Project	IEEE 802.16 Broadband Wireless Access Working Group < http://ieee802.org/16 >
Title	Embodied traffic indication during sleep-mode
Date Submitted	2004-06-25
Source(s)	KanggyuLee, JinaKim, SungwookPark, YunsungKim, TaeinHyon, YunsangPark, YeongmoonSon S a m s u n g E l e c t r o n i c Suwon P.O.Box 105, 416, Maetan-3dong, Yeongtong-gu, Suwon-si, Gyeonggido, Korea 442-742 Mail to: leekg@samsung.com jin0420@samsung.com sungwook98@samsung.com tseliot@samsung.com taein.hyon@samsung.com yunsang.park@samsung.com ym1004.son@samsung.com
Re:	This contribution is for call for contribution about IEEE P802.16e/D3-2004
Abstract	This contribution proposes the enhanced MOB_TRF-IND message and scenario for sleep mode.
Purpose	Adoption as part of Handover Ad-hoc recommendation to IEEE802.16e
Notice	This document has been prepared to assist IEEE 802.16. It is offered as a basis for discussion and is not binding on the contributing individual(s) or organization(s). The material in this document is subject to change in form and content after further study. The contributor(s) reserve(s) the right to add, amend or withdraw material contained herein.

Embodied traffic indication during sleep-mode

Figure 2—example, traffic information based on newly introduced signaling

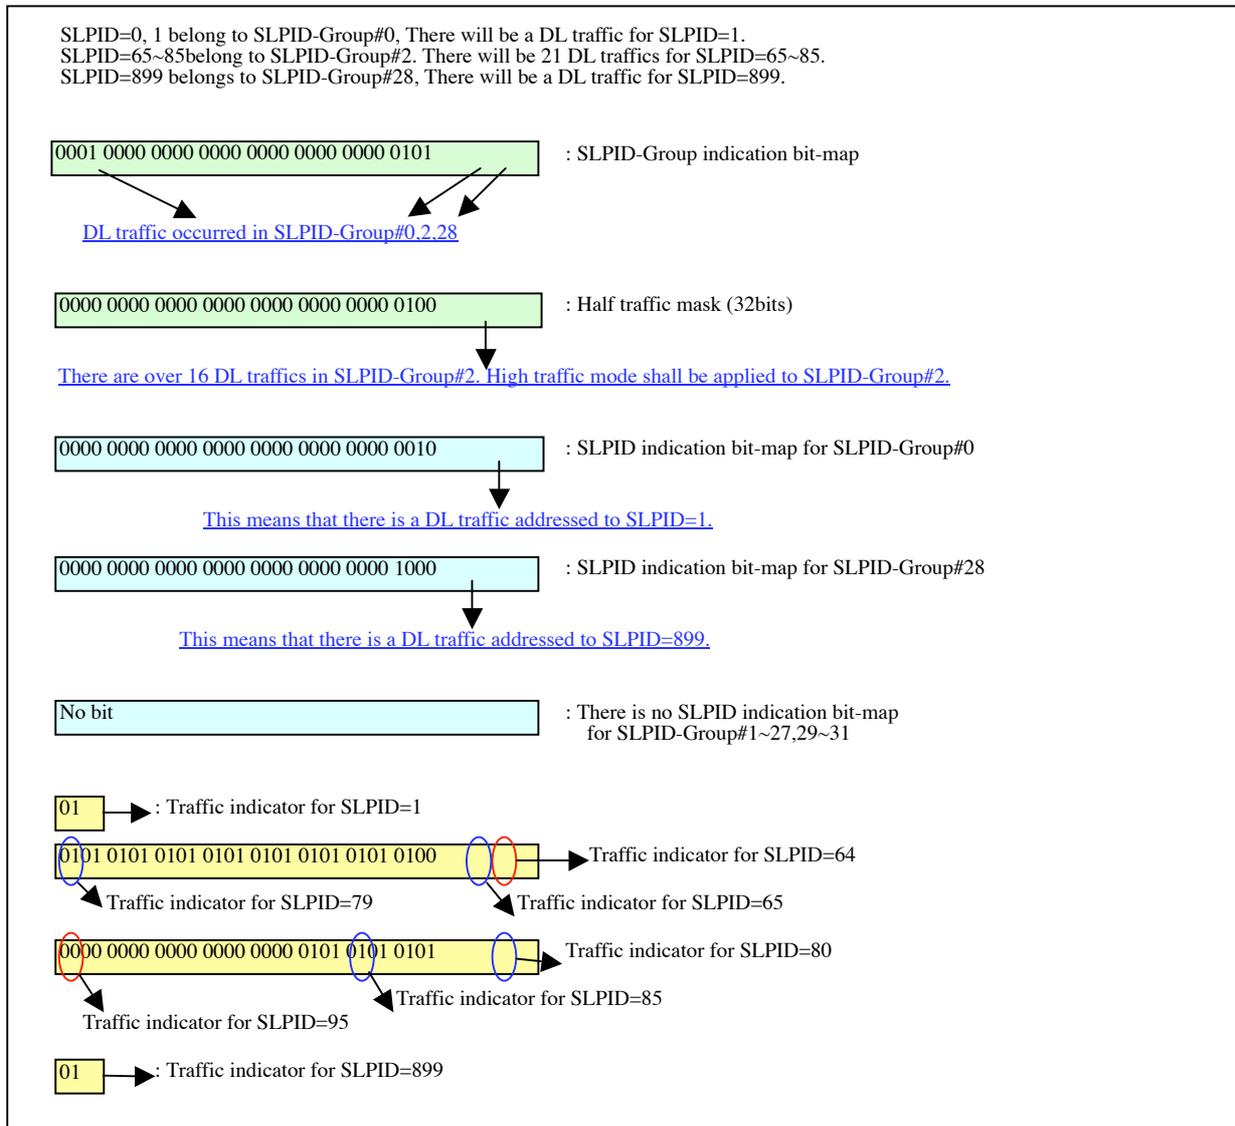
[example1 : Traffic information based on newly introduced signaling]

: The serving BS has assigned SLPIDs with the range from 0 to 900. All MSS except SLPID=0, 1, 65~85 and 899 are in normal operation. The MSSs with SLPID=0, 1, 65~85 and 899 are still in sleep-mode. DL traffic or periodic ranging opportunities for SLPID = 1, 65~85 and 899 are scheduled in the first incoming sleep interval. The content of all traffic indicators are assumed to be '01' or '10'.

Figure 3—example2, case ‘A’

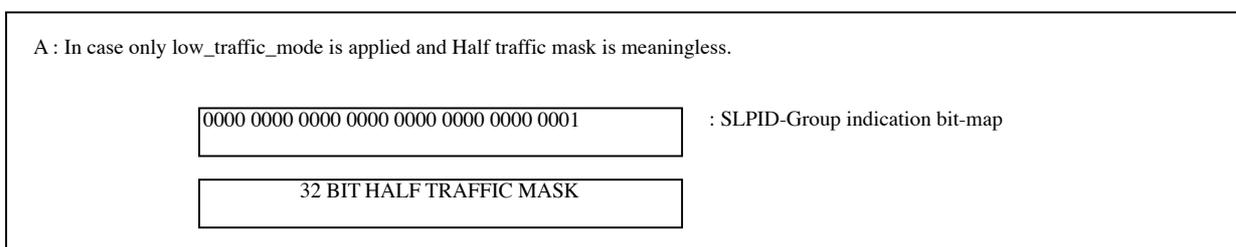
[example2 : Low_traffic_mode & High_traffic_mode signaling]

: The serving BS has assigned SLPID with the range from 0 to 19. No MSS returned to normal mode. DL traffic for SLPID=0~19 are scheduled in serving BS. The content of positive traffic indications are assumed to be '01'.

Figure 4—example2, case ‘B’

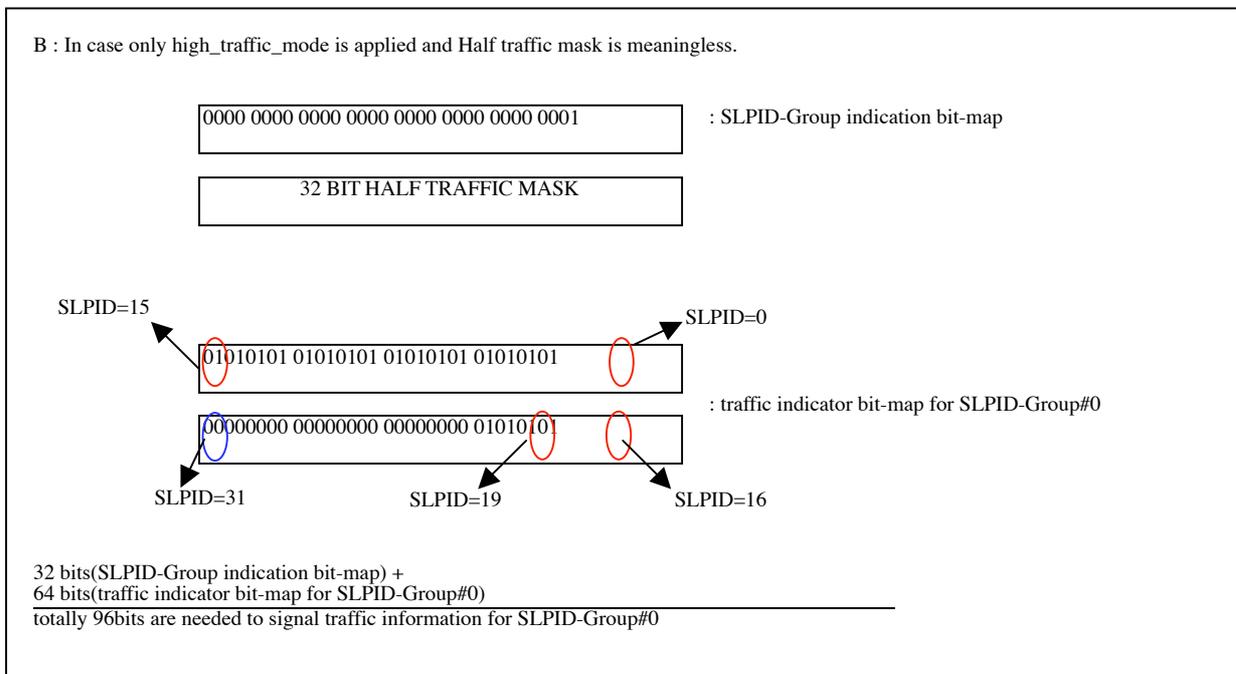
So, Half-traffic mask is useful tool to reduce the transmitted information bits in the MOB_TRF-IND message.
